Reference: 25/01708/OP Outline planning for Land opposite Heath Farm, Briary Lane, Royston

I write to register my strong objection regarding the above application. I live adjacent to the site, so I know it well. I have reviewed all the planning documentation produced on behalf of Gladman (hereafter referenced as 'the applicant').

Figure 1: Access Road (taken from drawing gta civls and transport drawing ref 13378-1100 P3 dated 08/05/2025)

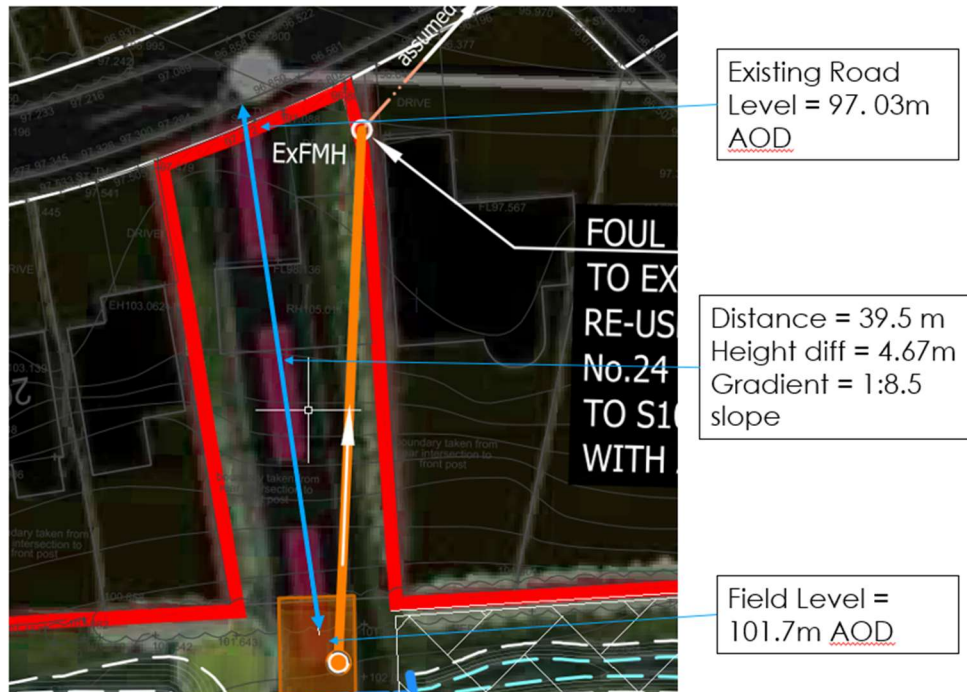
I have clearly shown in **Figure 1**, included as an appendix to this letter, the gradient of the access road will be at approximately 1:8.5 (11.76%).

The applicants proposed access road is therefore not compliant with highway standards or accessible for those with disabilities, the proposed site would naturally discriminate in only allowing those without physical disabilities to live there. It is highly unlikely residents who have health and age-related concerns, or those with young children, would be able to cycle or walk, and therefore with no access to bus services they will all be reliant on their cars.

Figure 6: Overland flows (taken from drawing gta civils and transport drawing ref 13378-1100 P3 dated 08/05/2025)

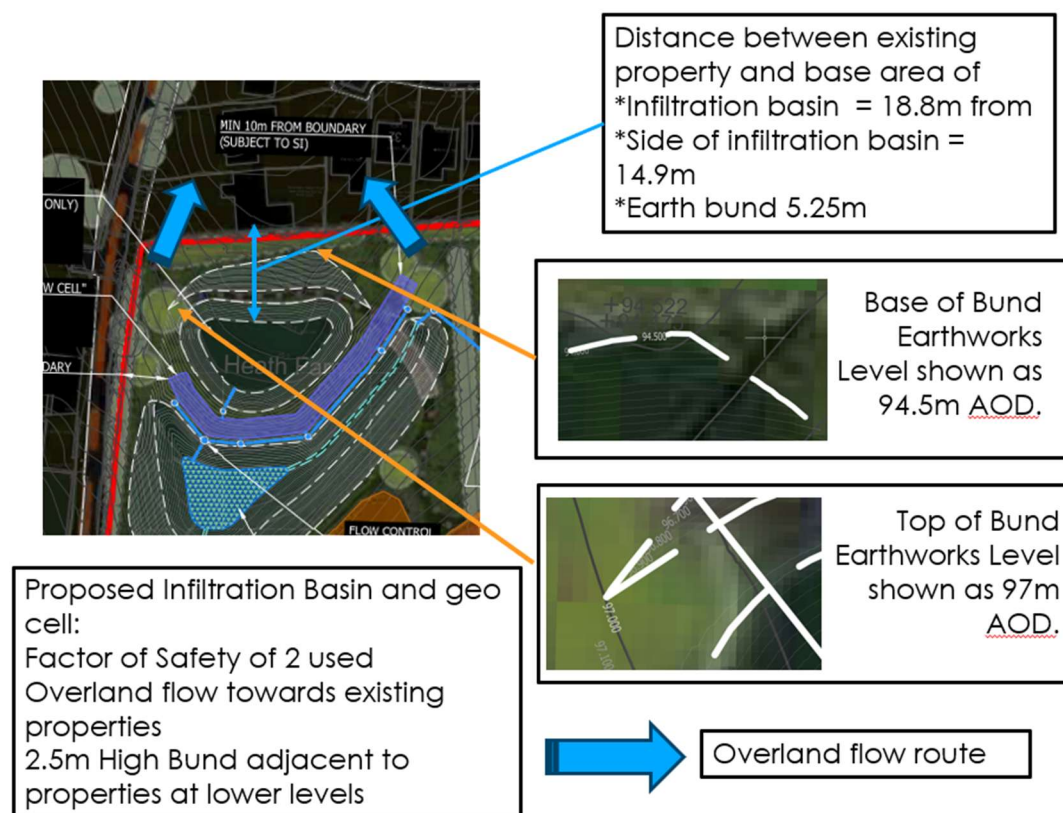
The impact of overland flow routes to offsite areas has also not been adequately addressed at this outline stage. Please refer to **Figures 6,7 8 and 9** in the attached appendices which clearly shows (based on the proposed and existing topography) overland flows are likely to be directed towards existing residents. Therefore, the potential risk to residential properties requires a minimum factor of safety of 10 to be applied to the surface water drainage attenuation calculations, the applicant has only used 2, significantly below national and recommended best practice guidance (CIRIA Guidance R157 and the National SuDS Standards 2025).

Figure 7: Overland flows (taken from drawing gta civils and transport drawing ref 13378-1100 P3 dated 08/05/2025)

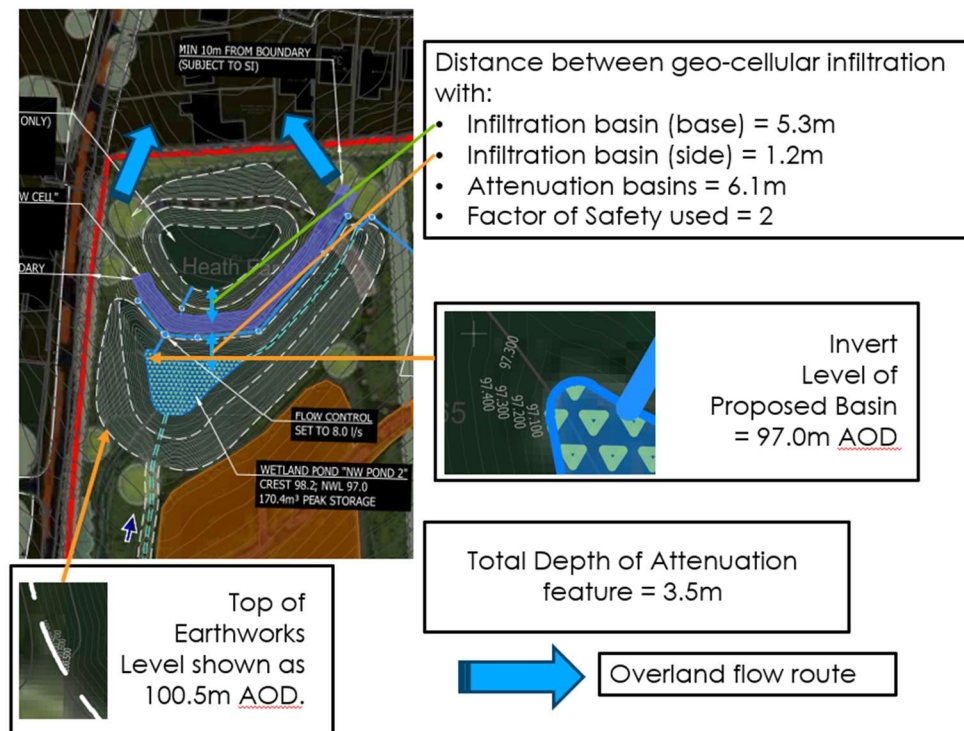
The applicants' proposals show the distance between infiltration features and attenuation drainage features are also significantly less than 10m, which presents a high risk from dissolution and subsidence (refer to **Figures 7 and 9**). This should be rejected by the Lead Local Flood Authority (LLFA).

Photo 1: Photograph showing width of proposed access route and lack of adequate verge space.

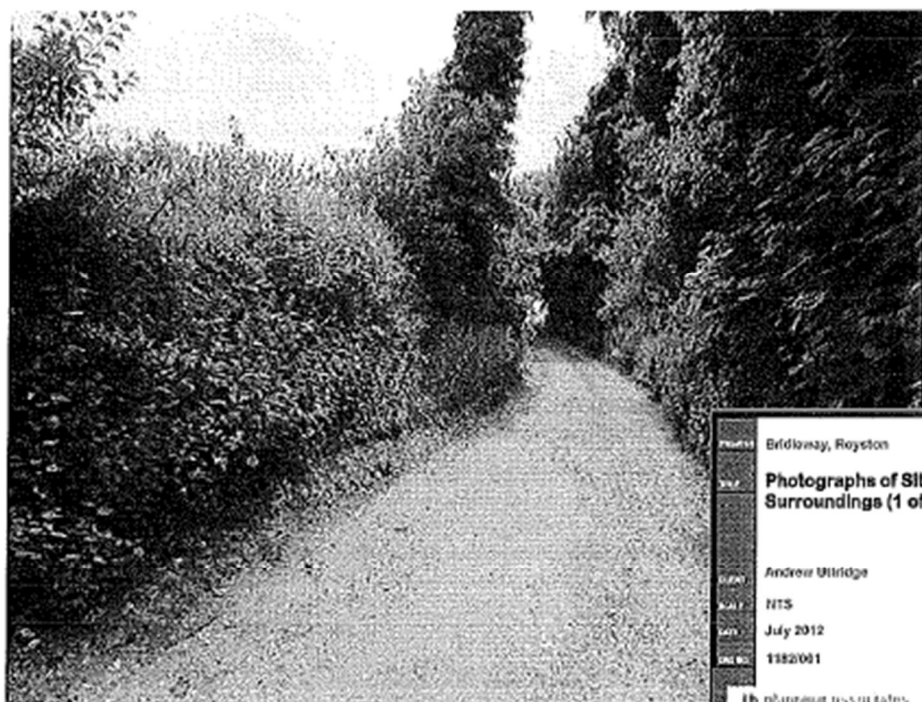
The proposed access route would use an unmade track that is designated on the Definitive Map as a bridleway (Bridleway 13), also known as Wicker Hall. We note that few details relating to alteration of the access track have been submitted with the application. The Design and Access Statement explains that the existing track will be resurfaced with macadam in order to support the additional traffic generated, with a cross fall to allow surface drainage. We wish to highlight the unsuitability of such work in relation to the route's status as a public bridleway, where pedestrians, cyclists and horses have priority. The macadam surface and drainage arrangements would be likely to force horses onto the verges, as stated in section 3.1.2 of the Design and Access Statement. The existing track is approximately 3 metres wide and along much of its length the width of the verges would appear to be insufficient to allow reasonable space for horses and other bridleway users to pass along safely (please refer to Appendix 1). Briary Lane would remain single track, with several additional passing places. The precise position and number of passing places is not specified, but it seems likely that these will involve widening the track in several locations, thus reducing the amount of verge available to horses and other users.
